# UNITED STATES PATENT AND TRADEMARK OFFICE

| APPLICATION NO.  | FILING DATE | FIRST NAMED INVENTOR      | ATTORNEY DOCKET NO. | CONFIRMATION NO. |
|--|-------------|---------------------------|---------------------|------------------|
| 10/788,799   | 02/27/2004  | Gerald Nelson             | 15420.49.1          | 7858             |

## Office Action Summary

## **DETAILED ACTION**

FIG. 9

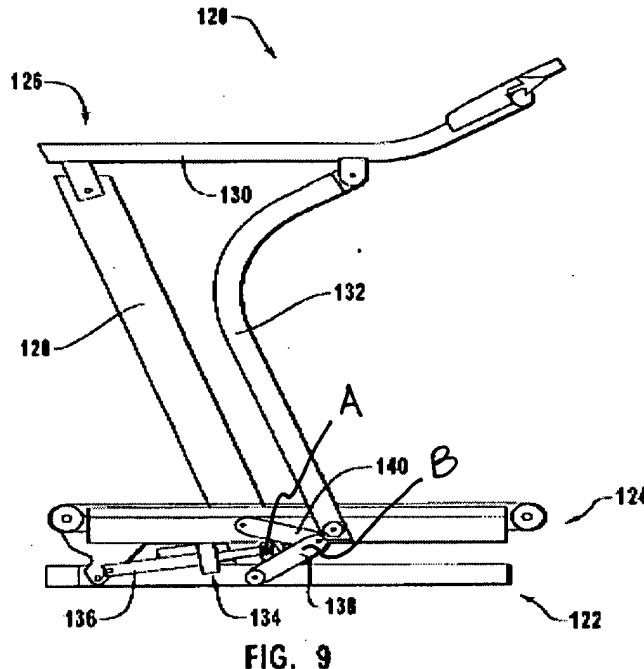
2. As to claims 26, 29, 30-33 and 38-41, Cutler et al. disclose a treadmill comprising a support base (122), a treadbase (124) pivotally coupled to the support base, and a lift apparatus having a lift motor assembly (134) pivotally coupled on a first end to the support base, and pivotally coupled on an opposite end to a first portion (A) of a cam (138), a second portion (B) of the cam being pivotally linked to the support base, the first portion being positioned beneath the second portion of the cam when the treadbase is in a horizontal position, and an incline link bar (140) having a first end pivotally coupled to a third portion of the cam and a second end of the incline link bar being pivotally coupled to the treadbase wherein a force applied by said motor assembly to said cam results in a generally equivalent force applied to said incline link bar to raise said treadbase, the cam has three pivot locations, the cam is driven by said at least one lift motor assembly to selectively raise or lower the treadbase, the lift assembly comprises a motor, a drive screw and a sleeve, said second portion of the cam is attached to a torsion bar/cross beam that is pivotally coupled to the support base, the

torsion bar pivotally links the cam to the support base and the cam is attached to the torsion bar and the torsion bar is pivotally attached to the support base (see Fig. 9 below & col. 10, lines 54-62).
